MCPB No. 19-134 Sketch Plan No. 320190080 Battery Lane District Date of Hearing: December 12, 2019

RESOLUTION

RE: Preliminary Plan No. 120190240 Battery District

We have completed our review of the preliminary plans uploaded to eplans on January 24, 2020. A previous plan was reviewed by the Development Review Committee at its meeting on July 23, 2019. We recommend approval of the plan subject to the following comments:

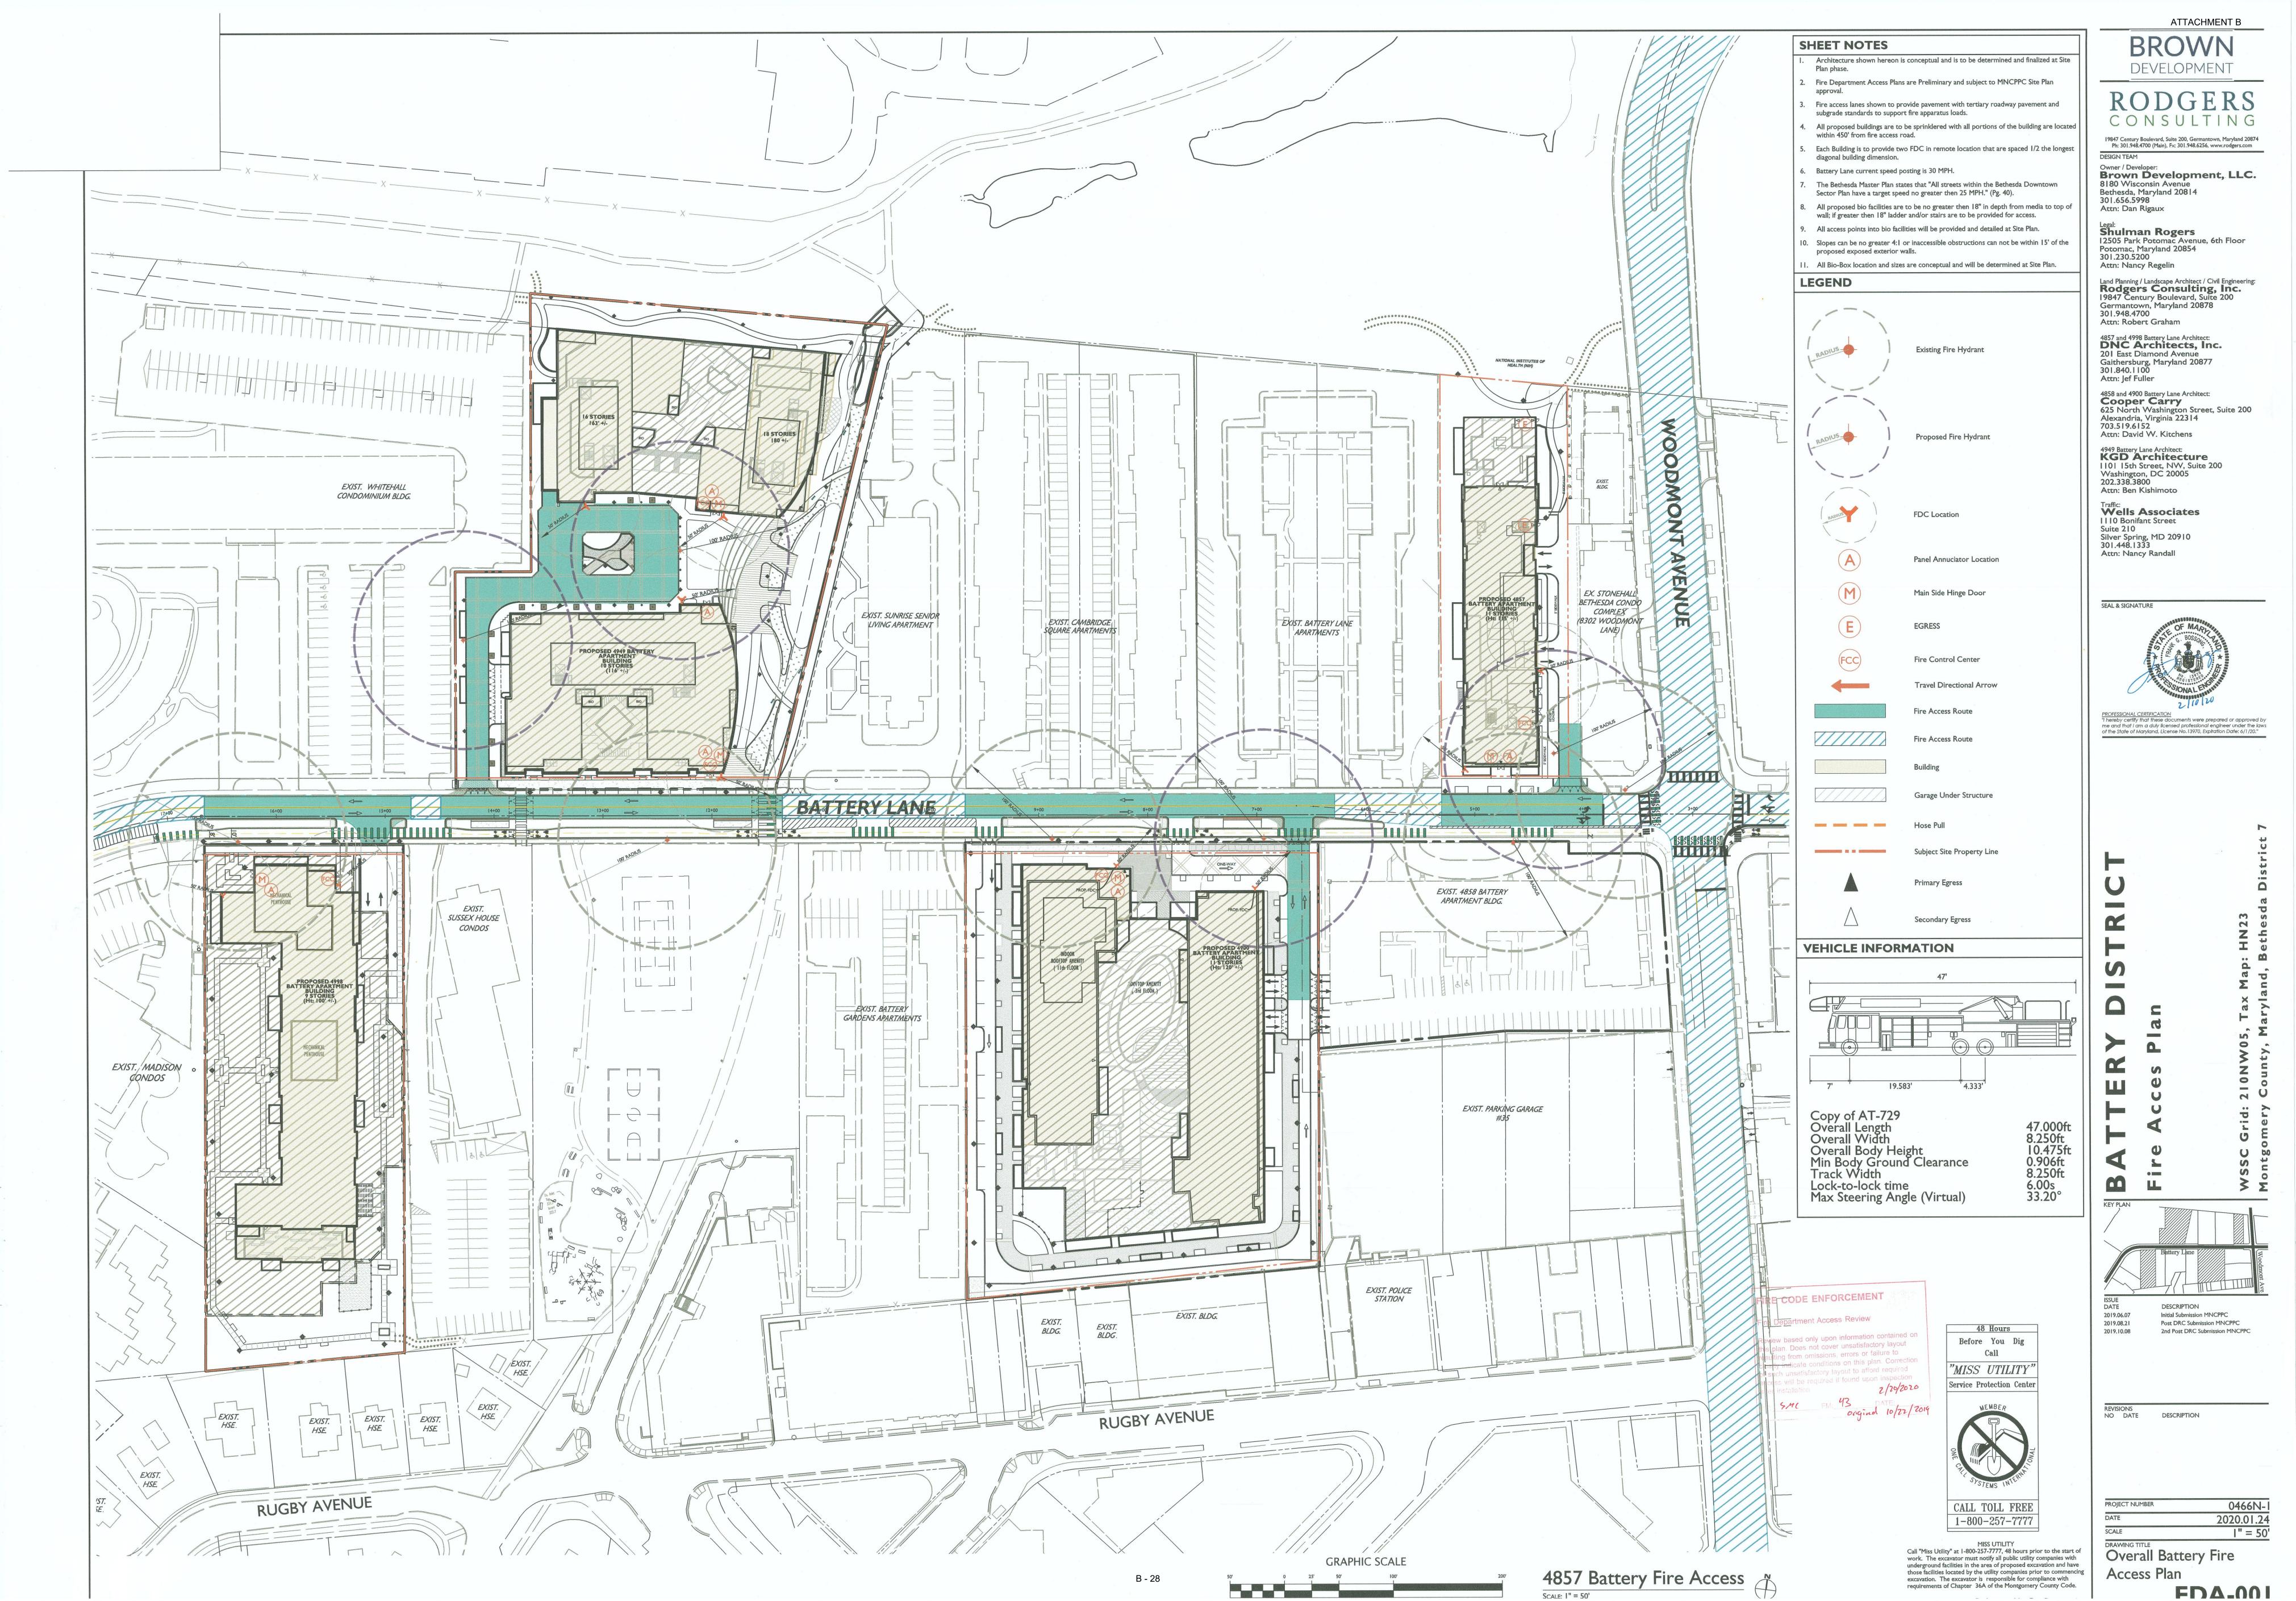
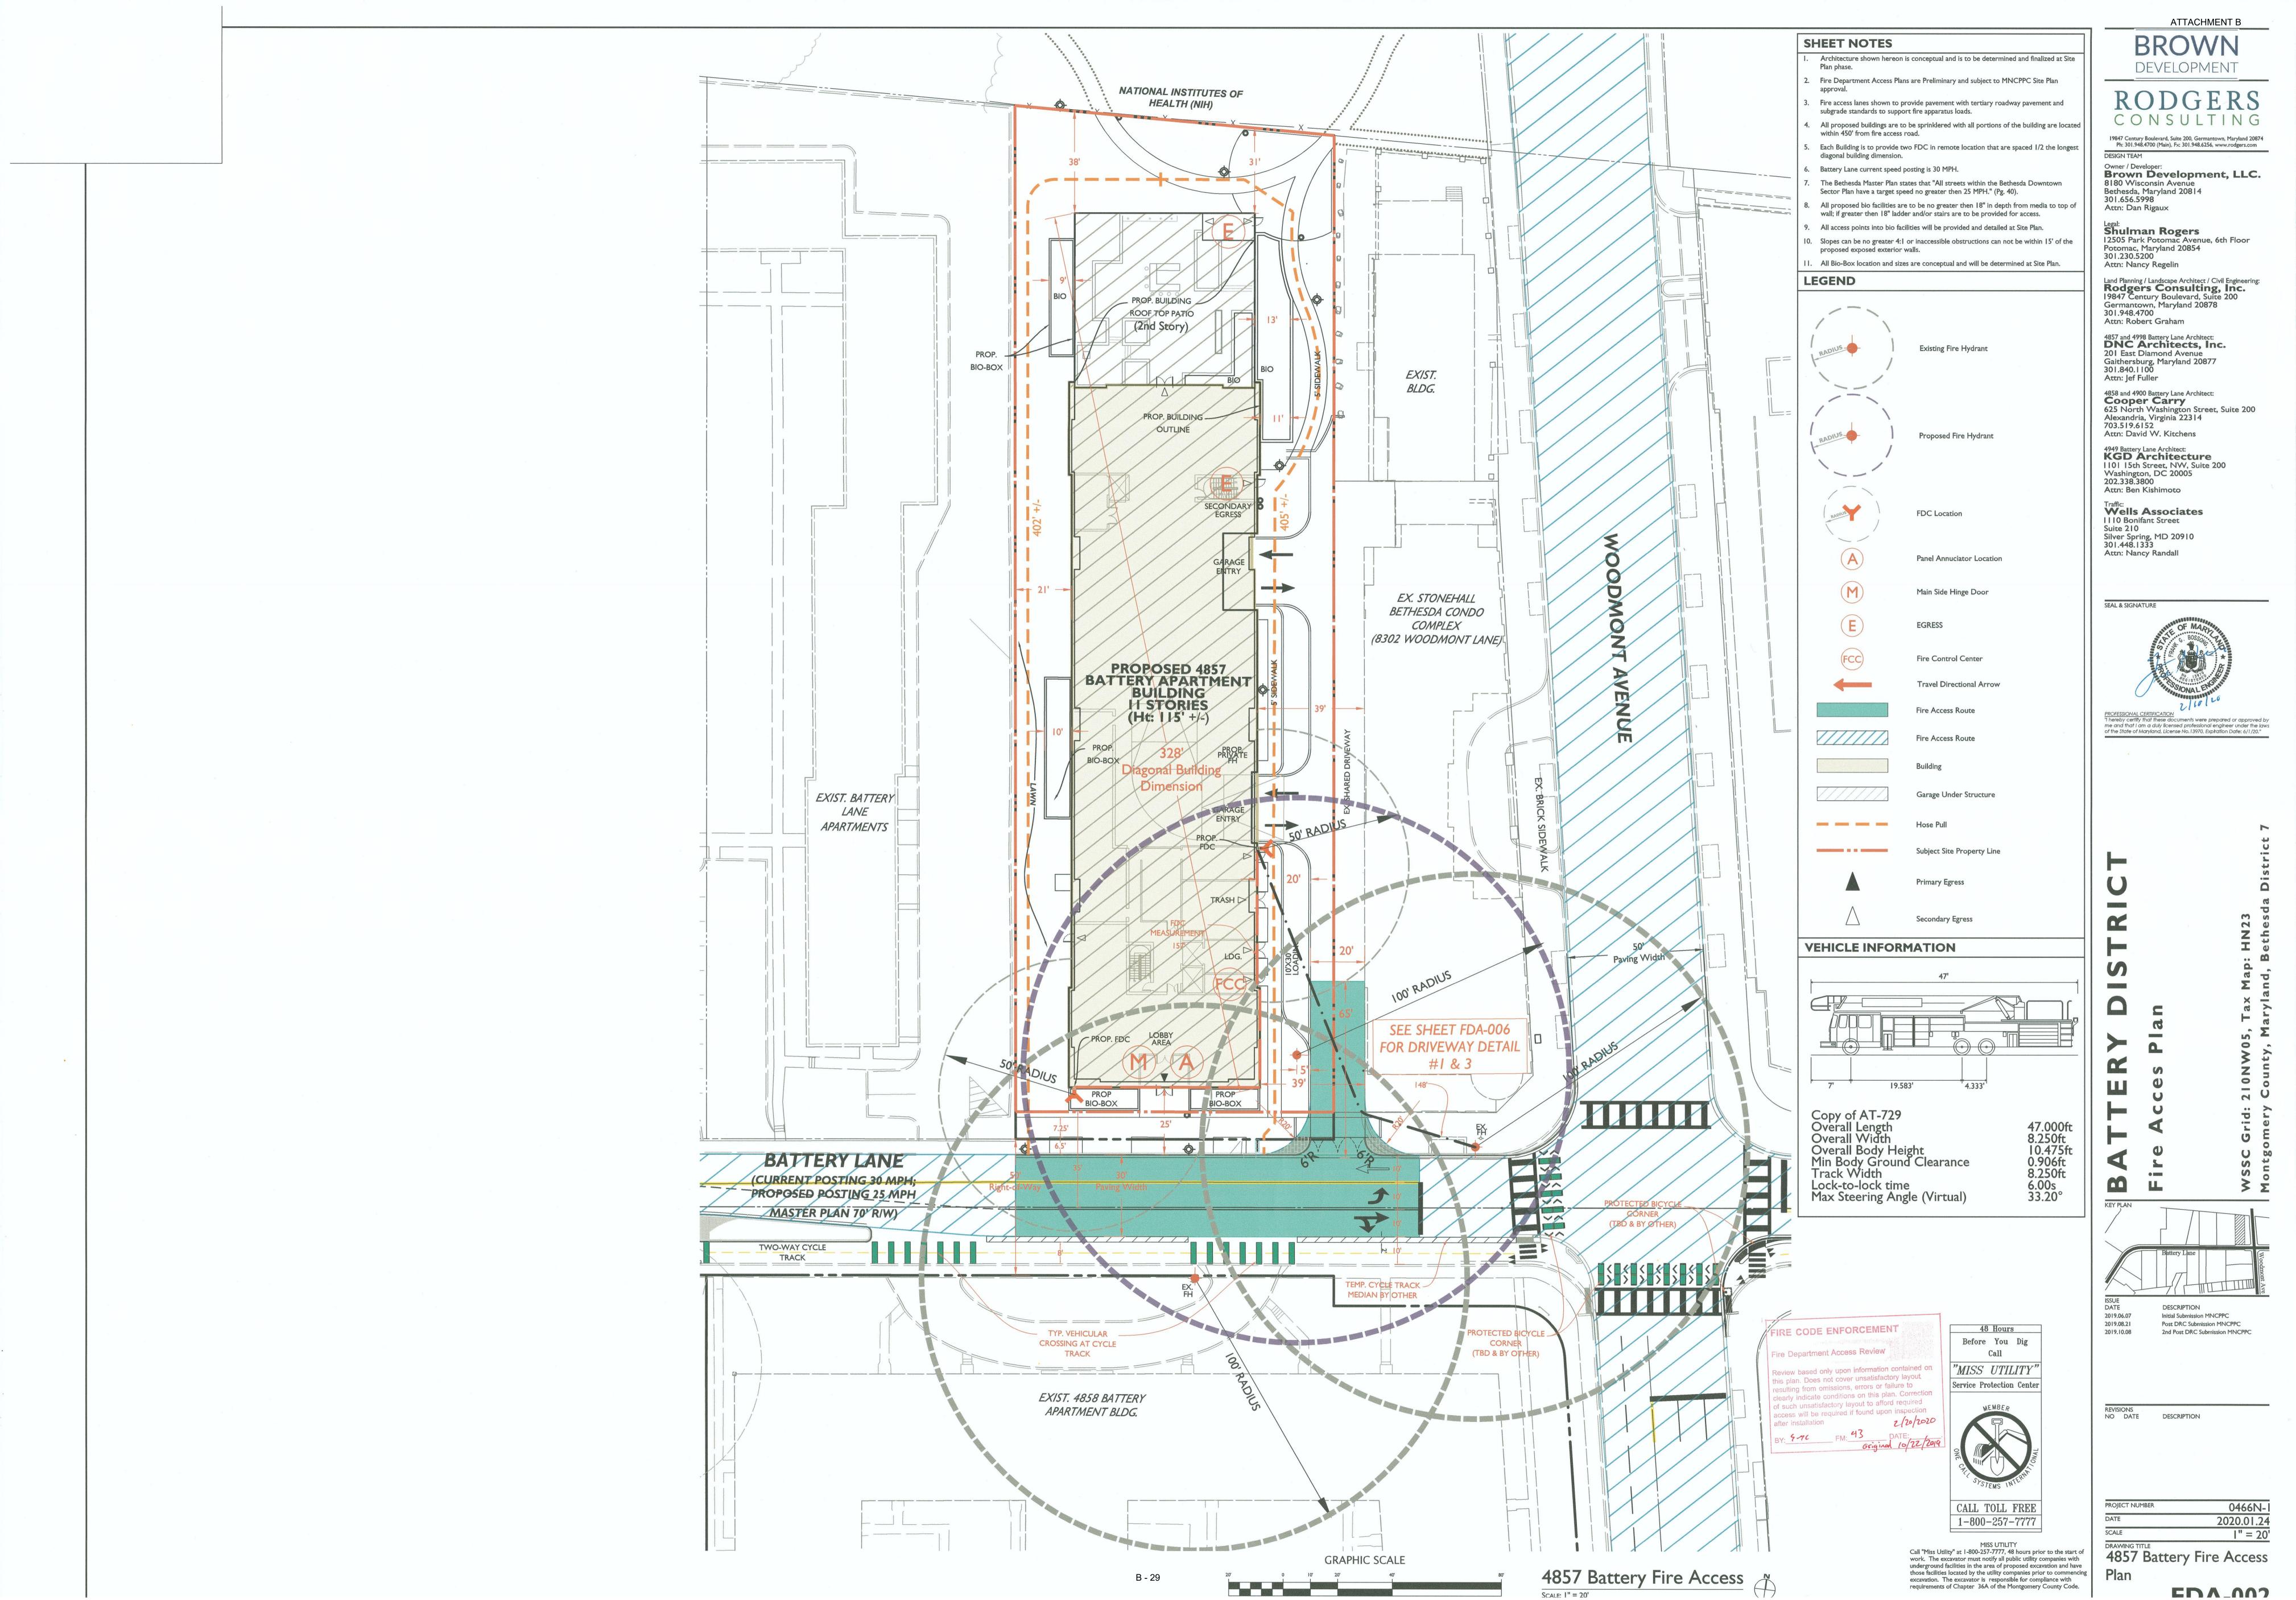
*** Engineer shall identify specific 3" mountable curb detail at Site Plan

*** Engineer shall further detail bike lane medians at fire department access driveways at Site Plan

******* GrassCrete GC2 surface shall not have a sod overlay

*** All fire lanes and fire department vehicular access paths are on grade (i.e. not on elevated decks)

*** Fire lanes orders to be submitted at Site Plan

2/20/2020 Revised Preliminary Plan - bikes lanes moved to south side of Battery Lane - add following comment to above:

*** Pedestrian access to bus stop at 4900 Battery Lane (Site C) shall not conflict with fire department vehicular access. Details to be submitted at Site Plan
